Date: 16th August 2022

Our ref.: C8341/AMG/9946

Re: C8341 – Land off Goat Mill Road, Merthyr Tydfil, Merthyr Tydfil County Borough Council Planning Application Ref. P/22/0064

**MINE ENTRIES AND OPENCAST EXCAVATION
IN RELATION TO PROPOSED SITE LAYOUT**

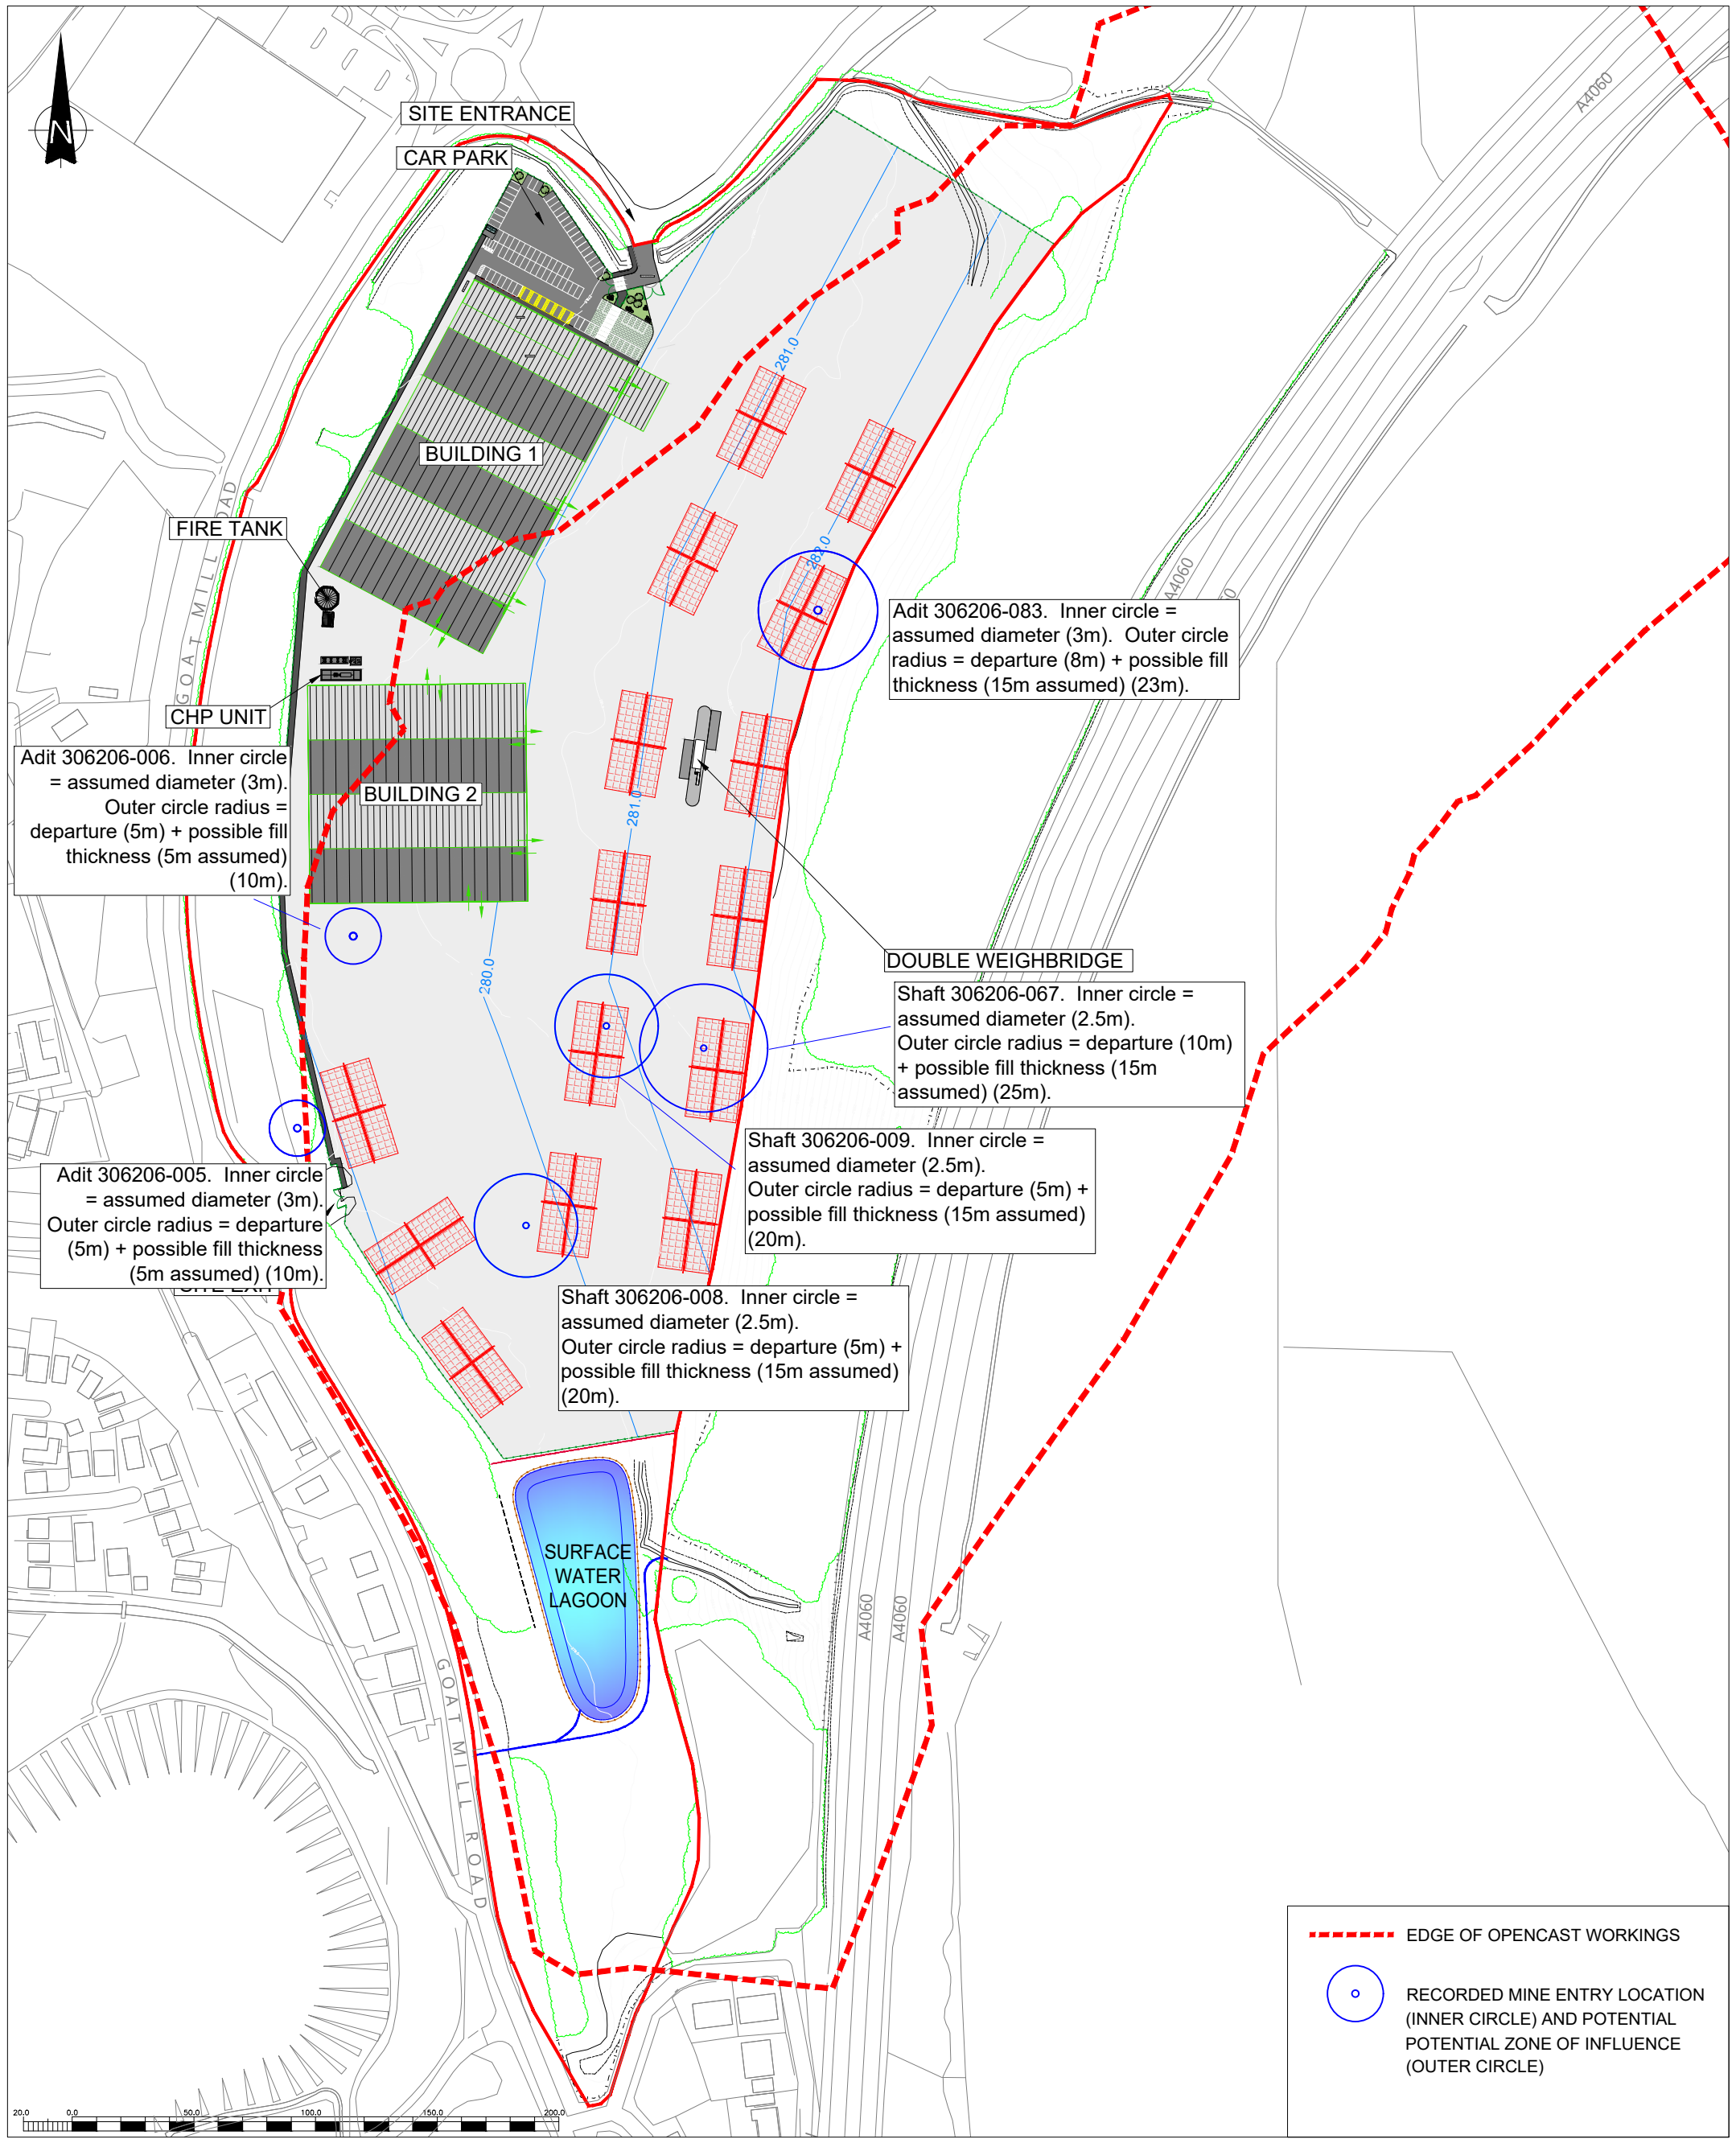
Please see attached Sirius Geotechnical Drawing No. C8341/05. This shows the coal mine entries that are recorded within the site by the CA, the known details of which are stated within the Sirius Geotechnical Ltd Preliminary Appraisal report for the site (report ref. C8341 Rev B, dated February 2022).

The locations of the mine entries shown on the Drawing are centred on the co-ordinates recorded in the CA Consultants Mining Report, contained within Appendix C of the Preliminary Appraisal. At each recorded mine entry location, there are two blue circles; the inner circle is the assumed diameter of the mine entry, as taken from the CA Interactive Viewer. The outer circle is the possible zone of influence of the mine entry, with the radius determined using the sum of two separate factors:

Drawing No. C8341/05 also shows the extent of excavation at the previous Great White Tip opencast coal mine, as taken from the CA Mine Abandonment Plan, Catalogue No. 17930/1, a copy of which is included within Appendix C of the Sirius Preliminary Appraisal report.

The extent of excavation at the historical opencast mine encompassed the majority of the proposed development site, including the full potential zone of influence of CA mine adit ref. 306206-006. It is therefore considered almost certain that the mine adit has been fully removed and does not present a risk to site stability.

As shown on Drawing No. C8341/05, there are four CA recorded mine entries in the east of the site (three shafts and one adit). As these are located well within the former opencast extraction boundary, it is considered almost certain that the adit (CA ref. 306206-083) has been fully removed, and possible that the mine shafts have been fully removed, by opencast mining, although it is possible that remnants of the mine shafts remain below the base of the backfilled opencast backfill.

The recorded locations of the five mine entries within the site, and their associated zones of influence, are located wholly within external areas of the proposed development. Although there are proposed plastic waste bale storage areas that coincide with the recorded locations of four mine entry locations or their zones of influence, it should be noted that these are not classified as structures for the purposes of assessing coal mining stability risks, i.e., they do not require foundations, are only 4m high, impose only a very light loading (c. 12 kPa) on to the external surfacing, and are not being sensitive to small ground movements.

Consequently, storage of plastic waste bales should not be considered as 'building over or within the influencing distance of a mine entry' in relation to the CA's policy in this respect, and the objection to the planning application should be removed.

Notwithstanding the above, the site is located within a Development High Risk Area with respect to several coal mining hazards, and the Preliminary Appraisal report recommends intrusive investigation to further inform the assessment of coal mining stability risks to the proposed development, including targeted investigation of the recorded mine entries that may remain below proposed developed areas following opencast mining, using trial trenching and rotary probehole drilling.

Construction of paved external areas in industrial developments over / within the zone of influence of mine entries has been successfully undertaken elsewhere with CA approval following appropriate site investigation and, where necessary, stabilisation works. Dependent on the depth to any mine shafts that remain on the site following opencast mining, possible options for mitigation of future instability risks could include filling shafts with suitable granular material, provision of a concrete shaft plug, drilling and grouting, provision of geosynthetic reinforcement of shallow soils, construction of shaft caps at rockhead, or above rockhead, supported on piles, or a combination of two or more of these procedures.

Treatment of mine adits may include excavation at near surface, and placement of suitable engineered fill materials, and filling by drilling and grouting, at greater depths.

DRAWING TITLE
SITE LAYOUT

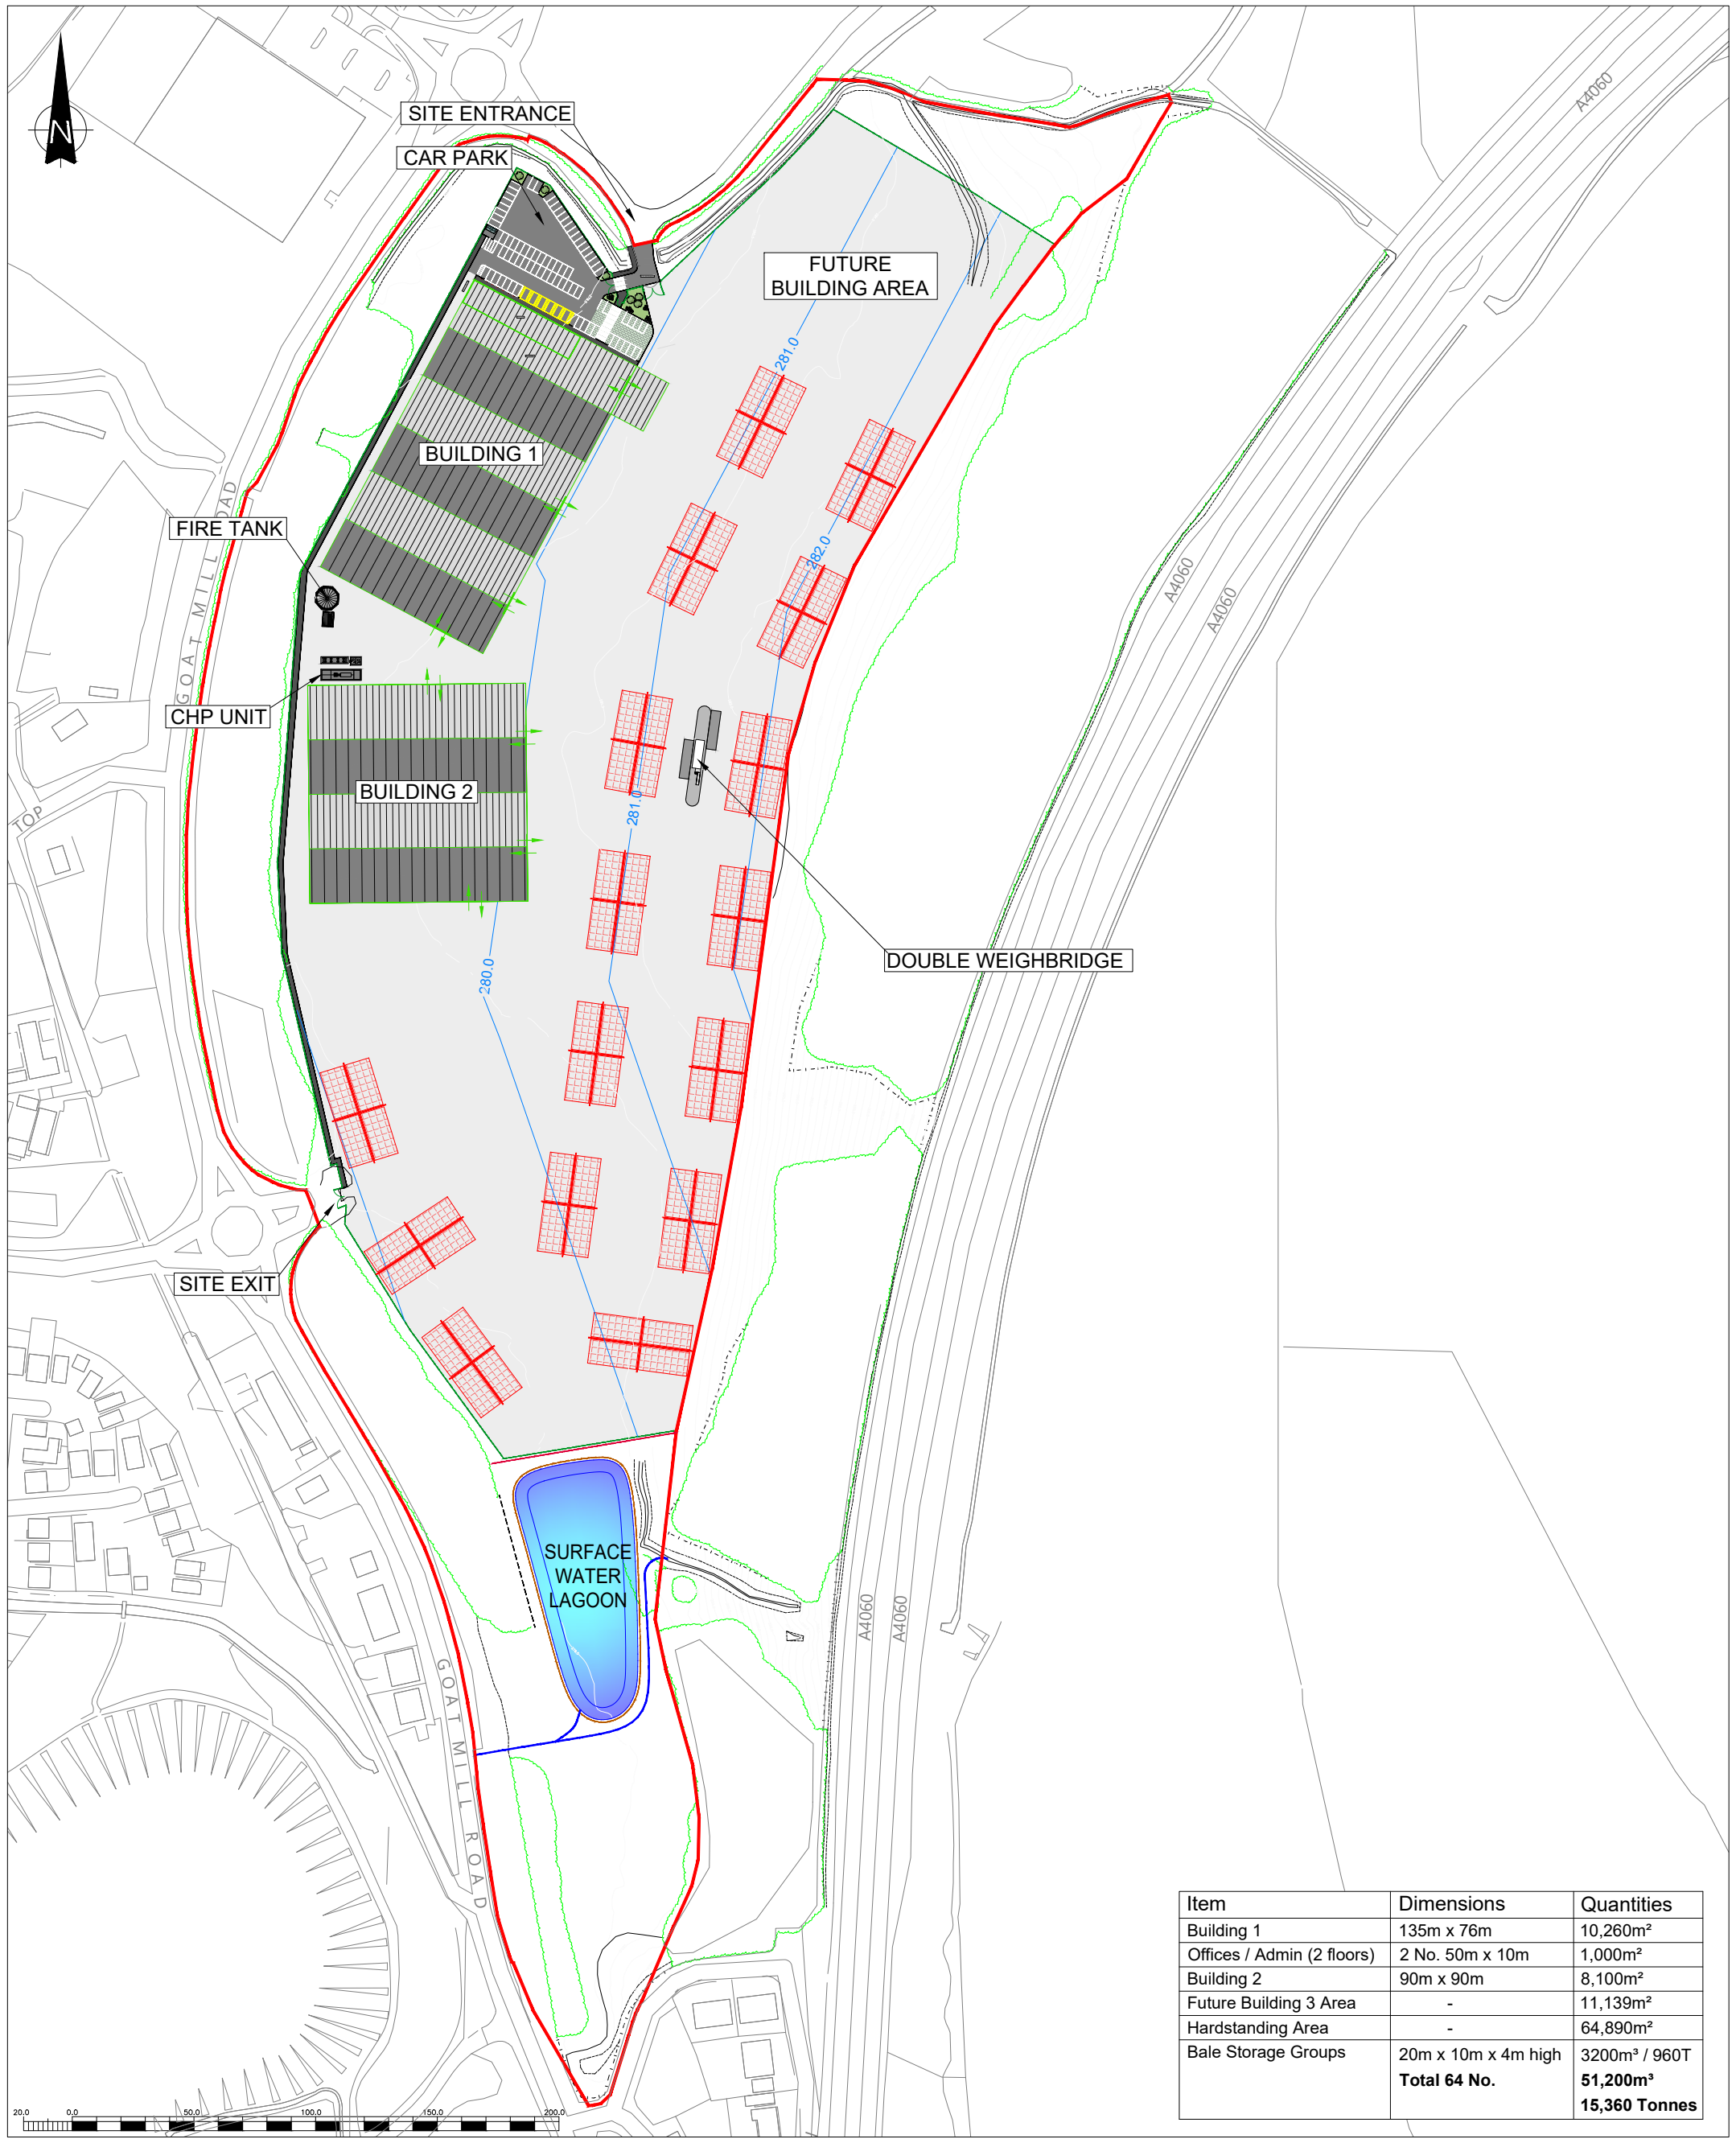
The proposed site layout has now been amended, so that Building 2 is no longer affected by any recorded mine entries, as shown on Sirius Planning Drawing No. JAY1001/04/06 Revision 1, dated 08/08/2022 (copy attached).

BUILDING 2 AMENDED
